EPC STORMWATER REVIEW COMMENTS ARE  
SHOWN IN ORANGE BOXES WITH BLACK TEXT

## The Cottages at Mesa Ridge Preliminary Drainage Report

Add PCD File No. PUDSP2111

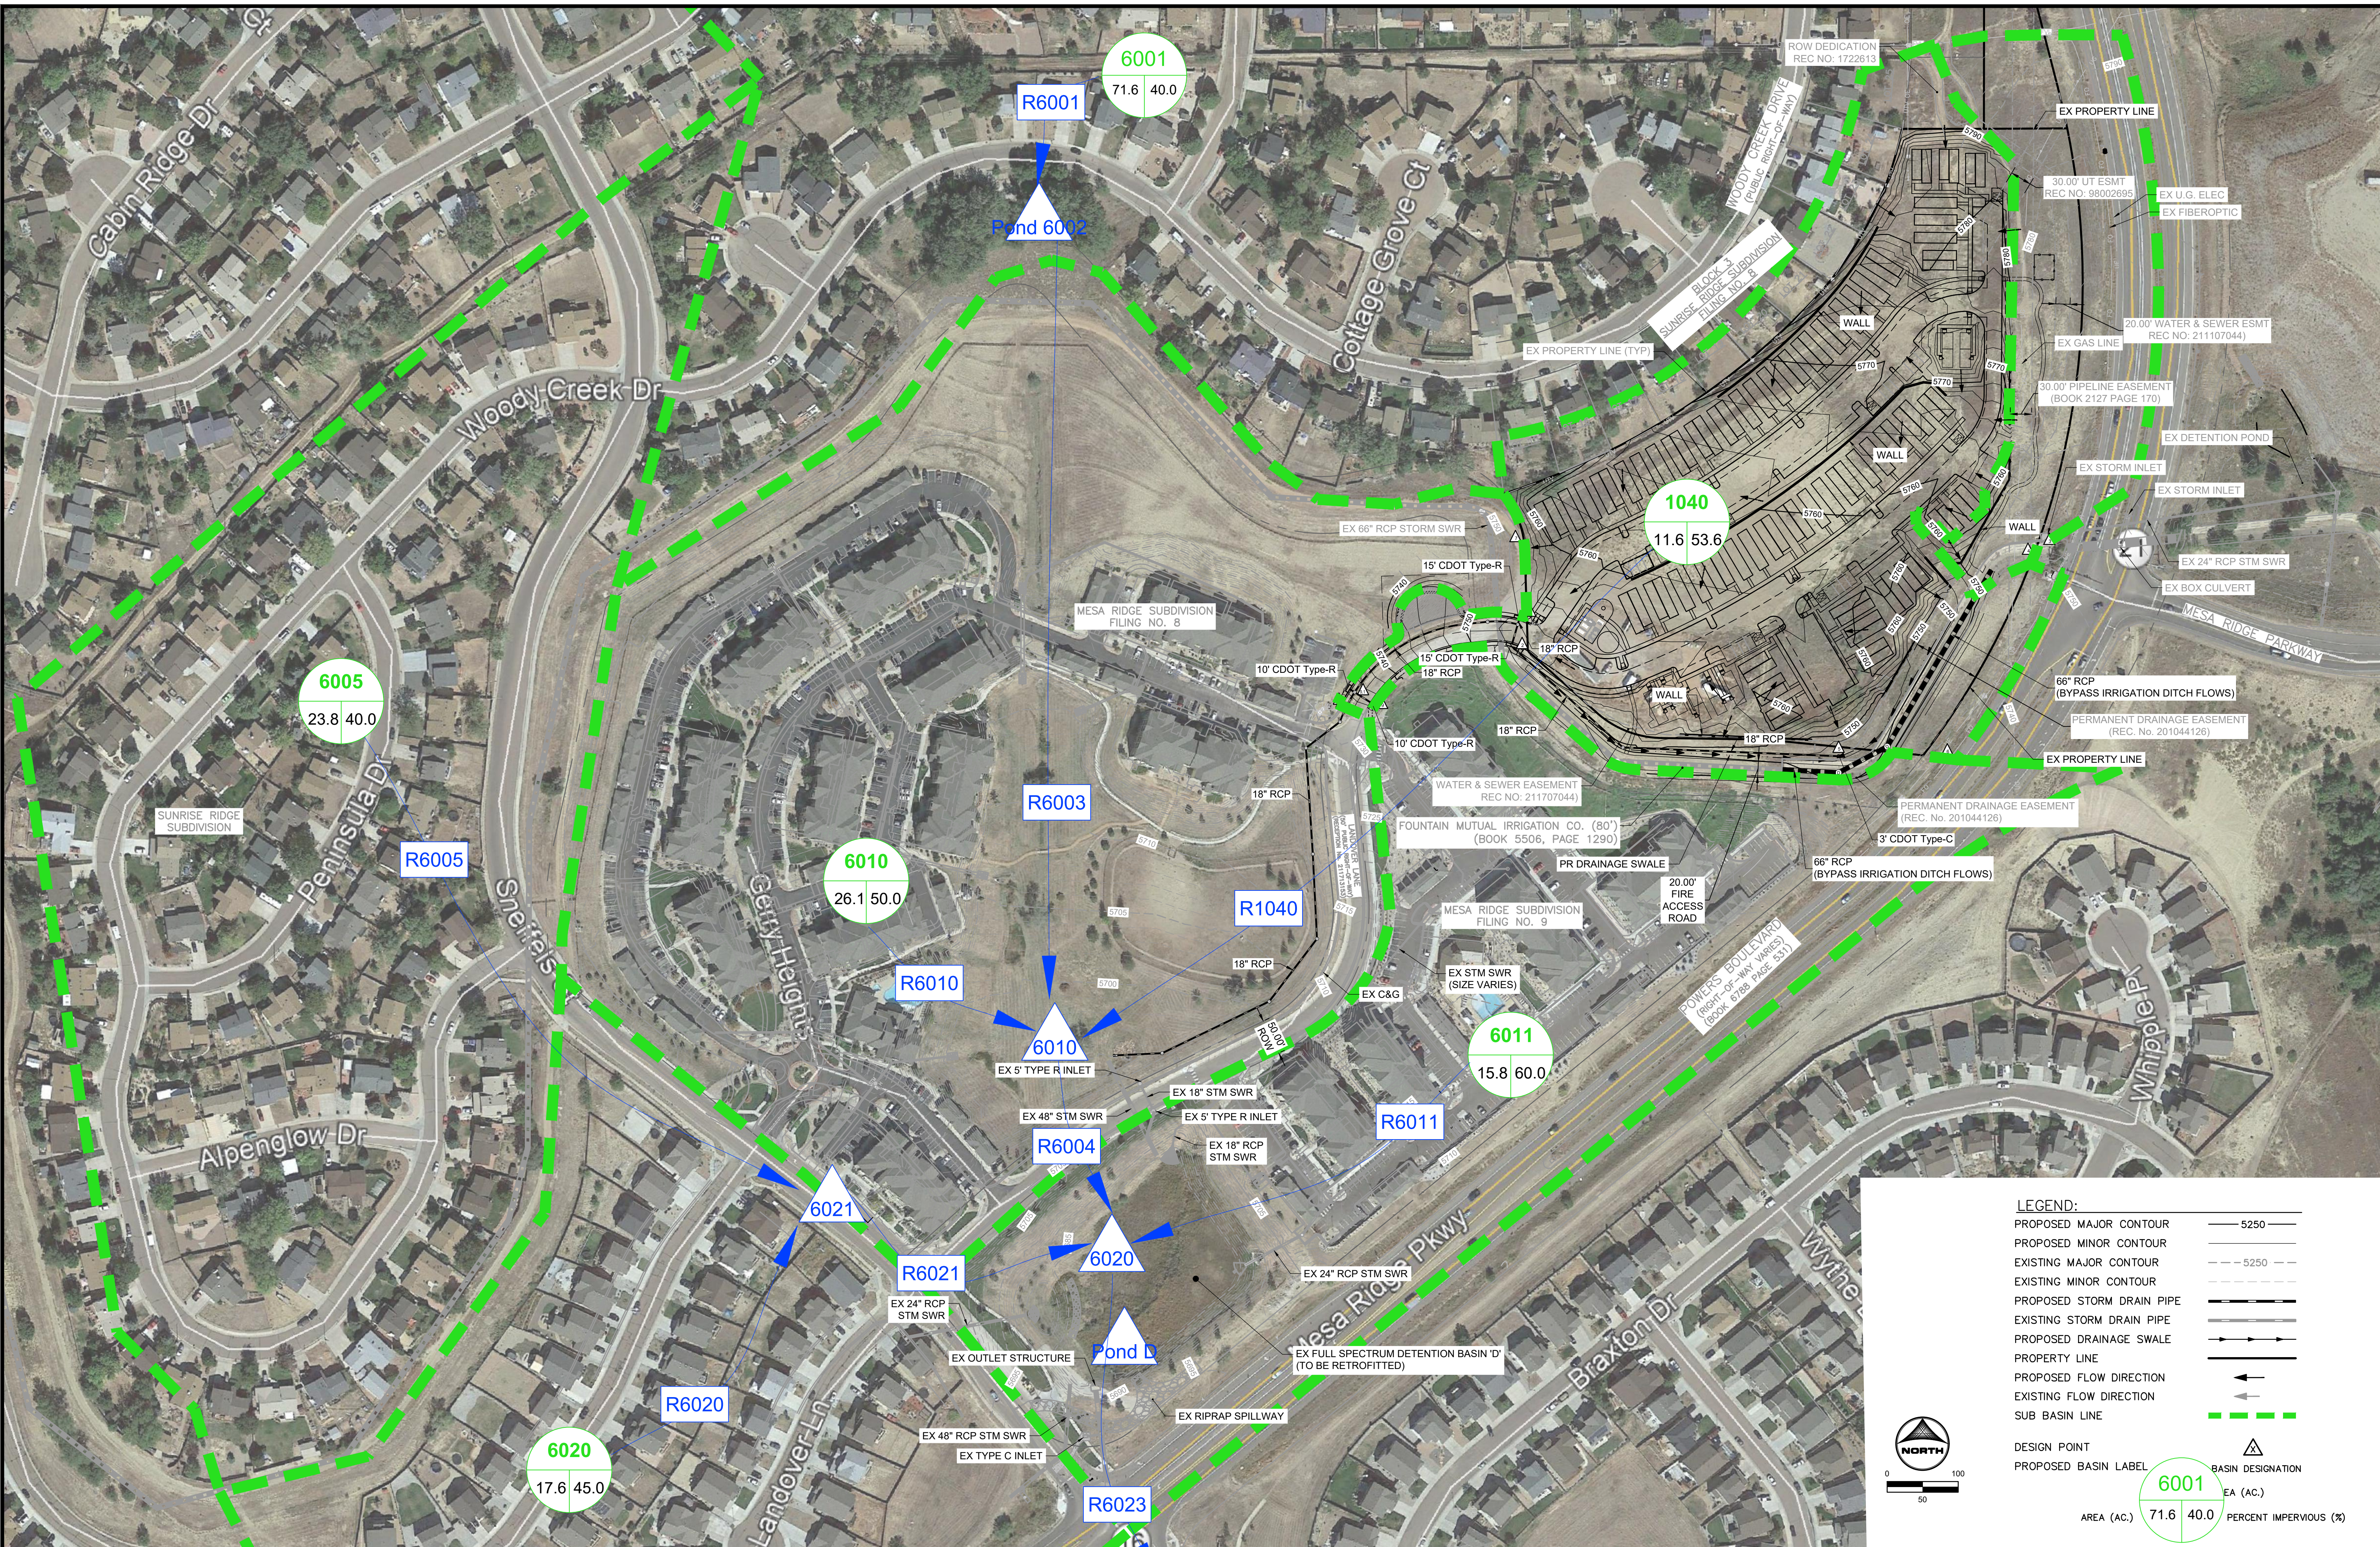
FYI: at final drainage report, analysis that Landover Ln has the capacity to accept the flow by of these inlets shall be provided.

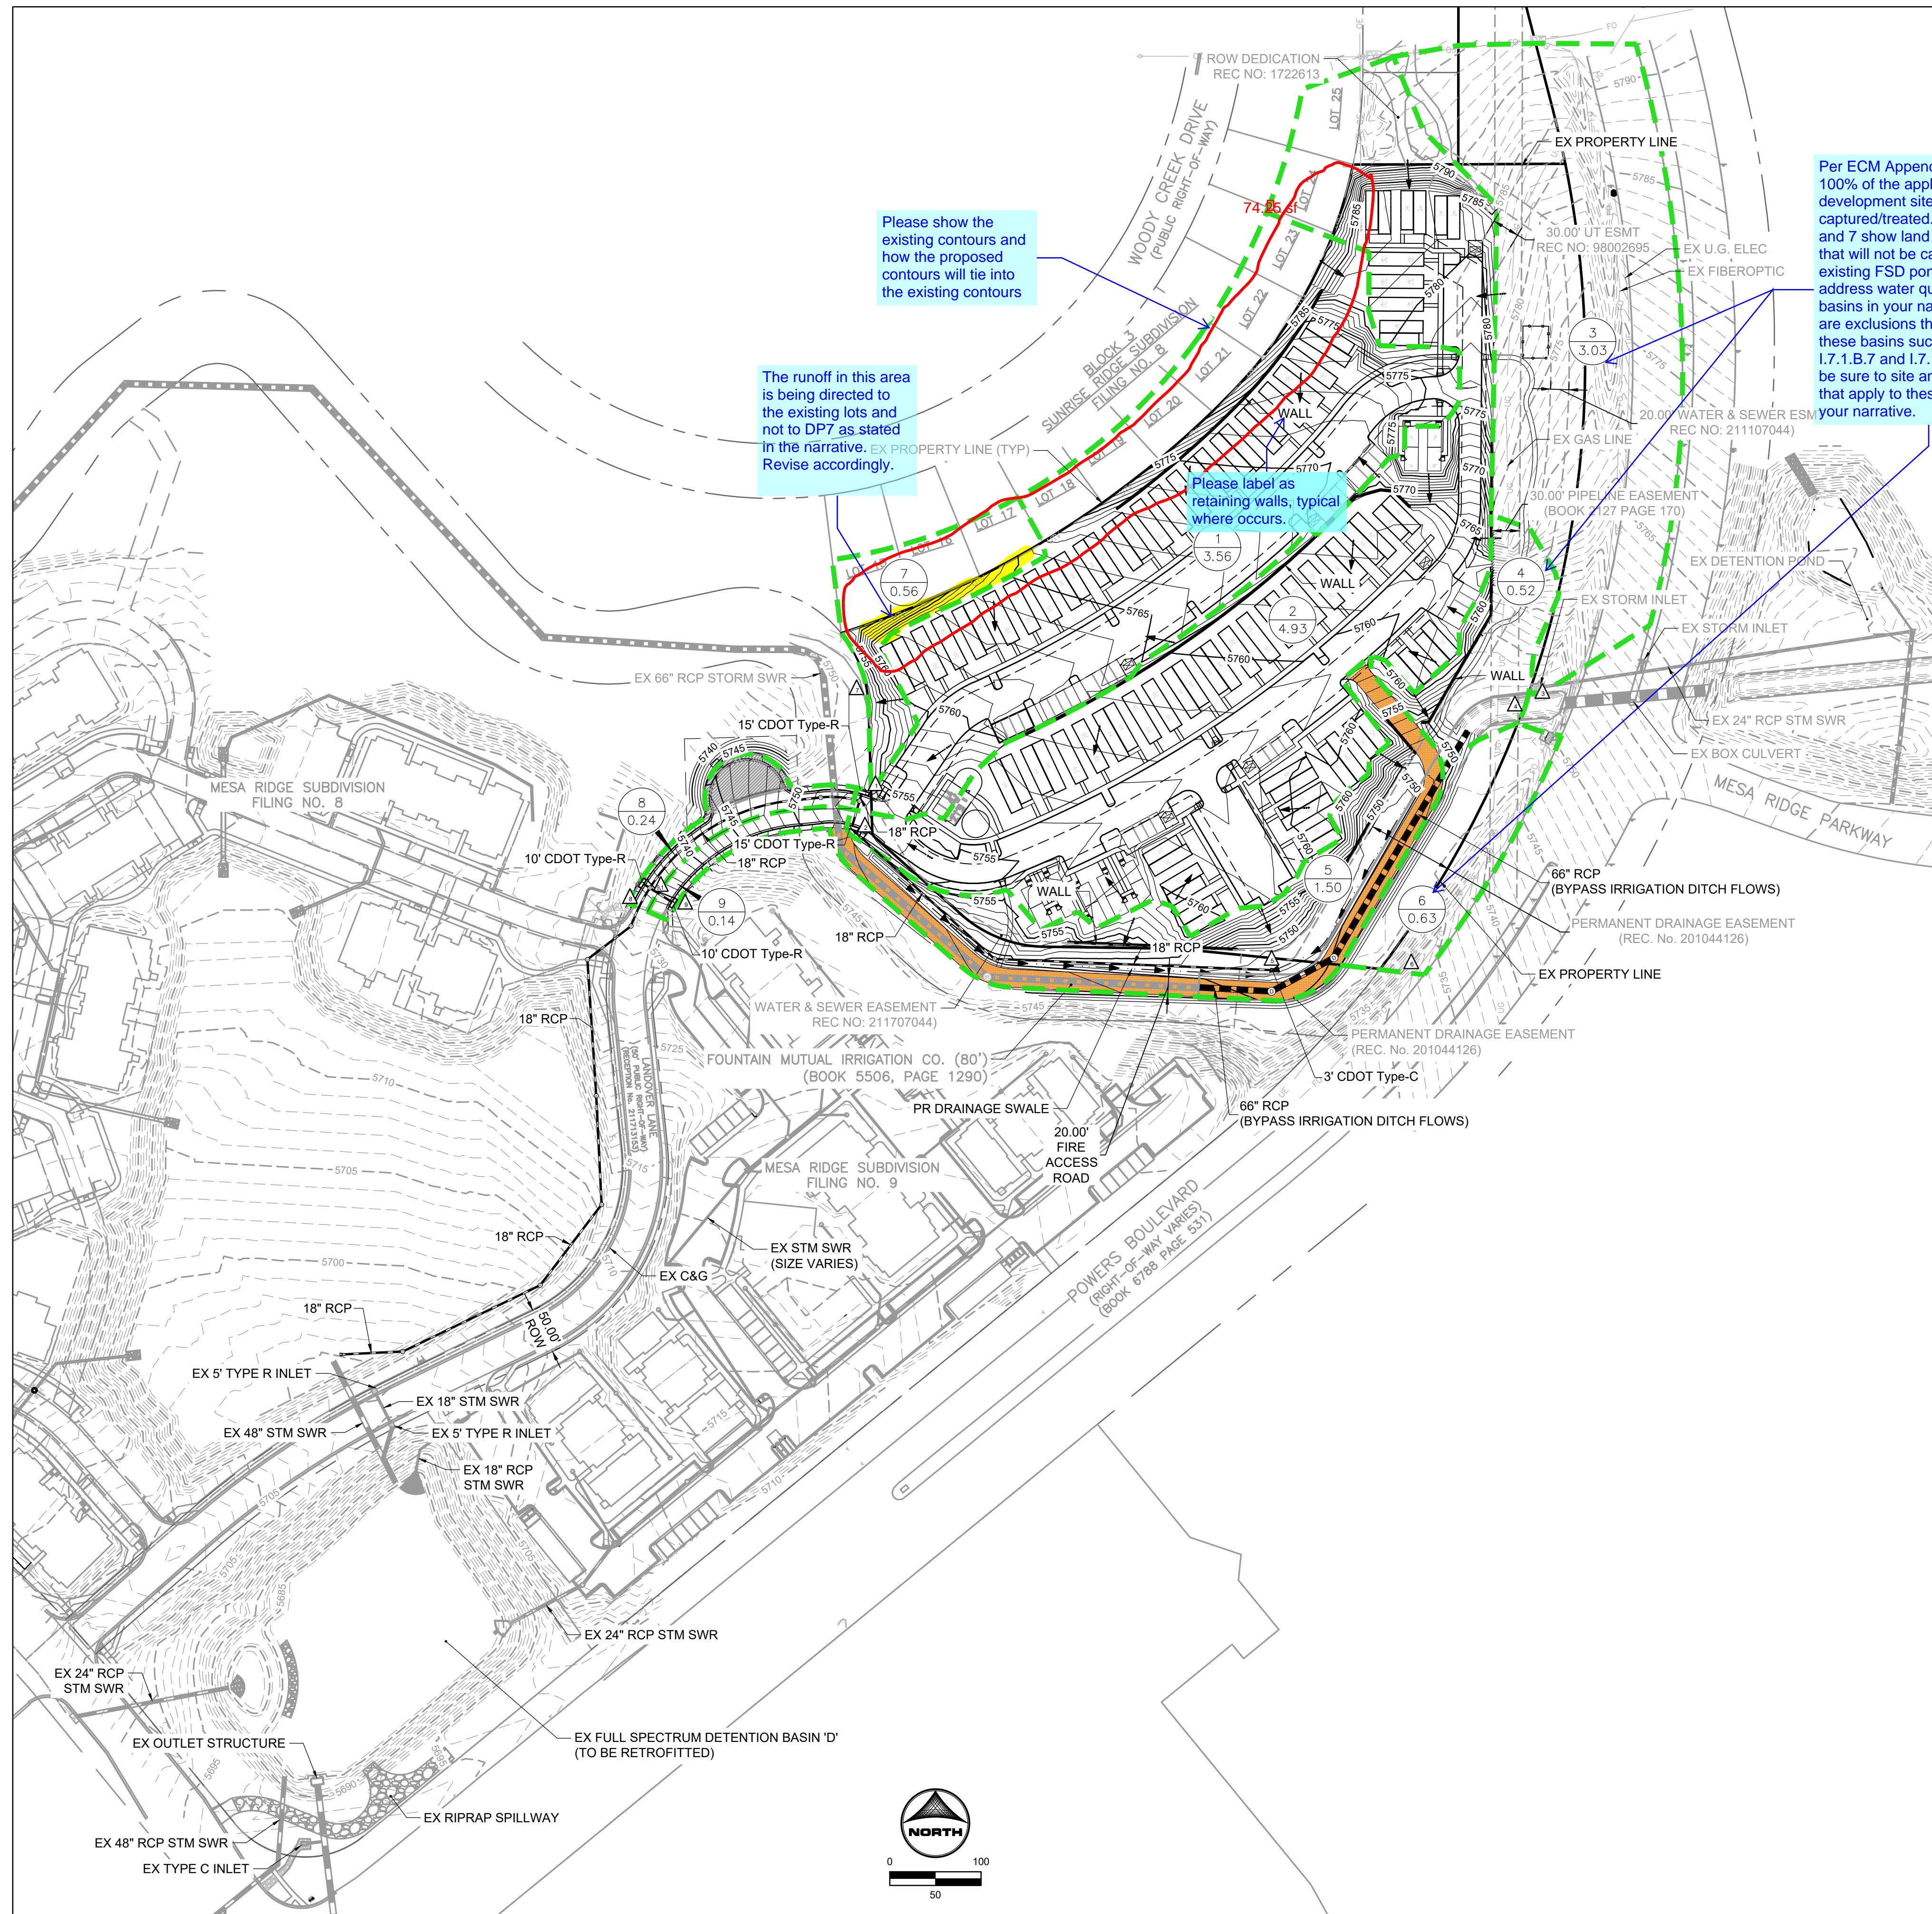
Per ECM Appendix I.7.1.C.1., 100% of the applicable development site shall be captured/treated. Basins 3, 4, 6, and 7 show land disturbance that will not be captured by the existing FSD pond. Please address water quality for these basins in your narrative. There are exclusions that may apply to these basins such as ECM I.7.1.B.7 and I.7.1.B.9. Please be sure to site any exclusions that apply to these basins in your narrative.

Please show the existing contours and how the proposed contours will tie into the existing contours

The runoff in this area is being directed to the existing lots and not to DP7 as stated in the narrative. Revise accordingly.

Please locate the design point on the plan.
